# service bulletin

**No. 96-2**

## Water In Fuel Module (WIF) Warning Light

MCM/MIE D7.3L/270 Diesel Engines

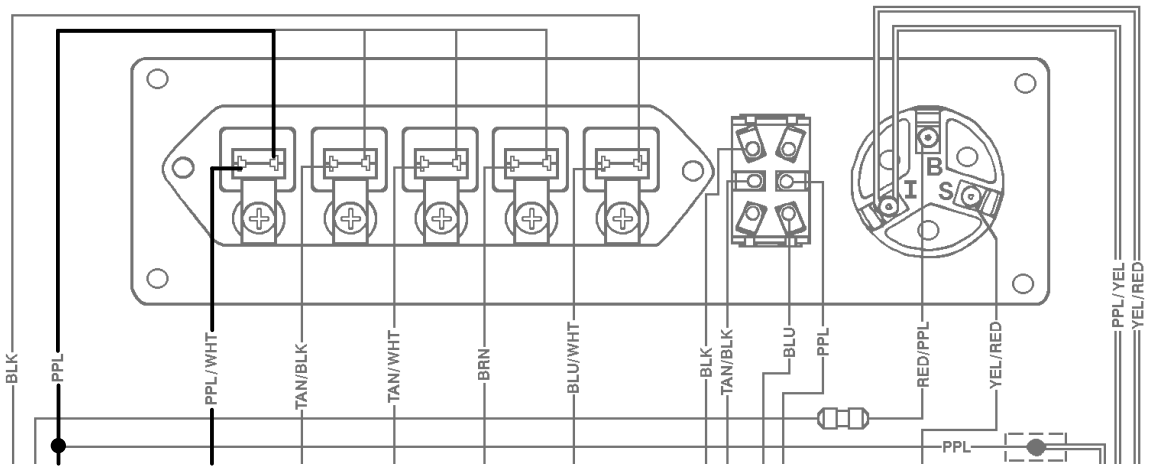
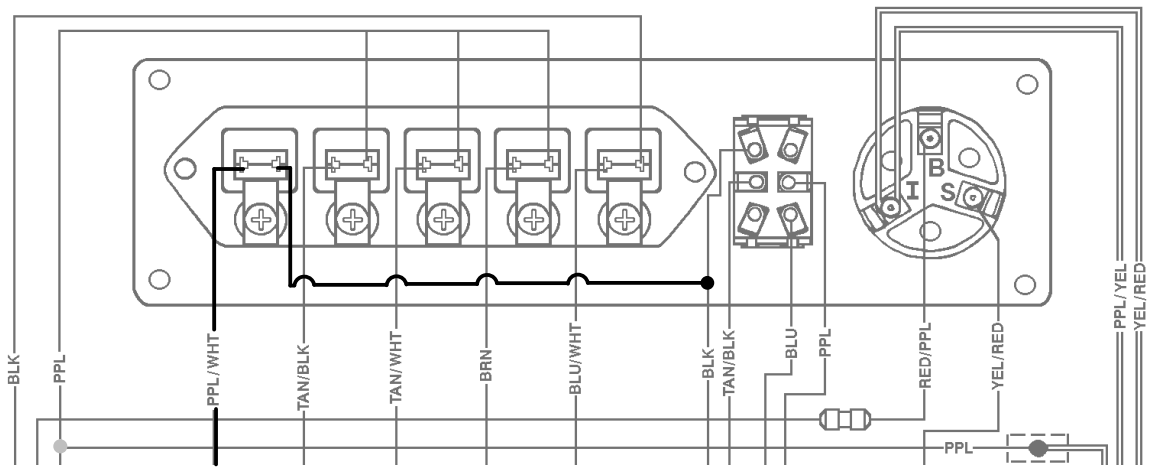
The warning light on the Engine System Monitor Panel may not operate correctly.

Change wire on WIF light on Engine System Monitor Panel as shown.
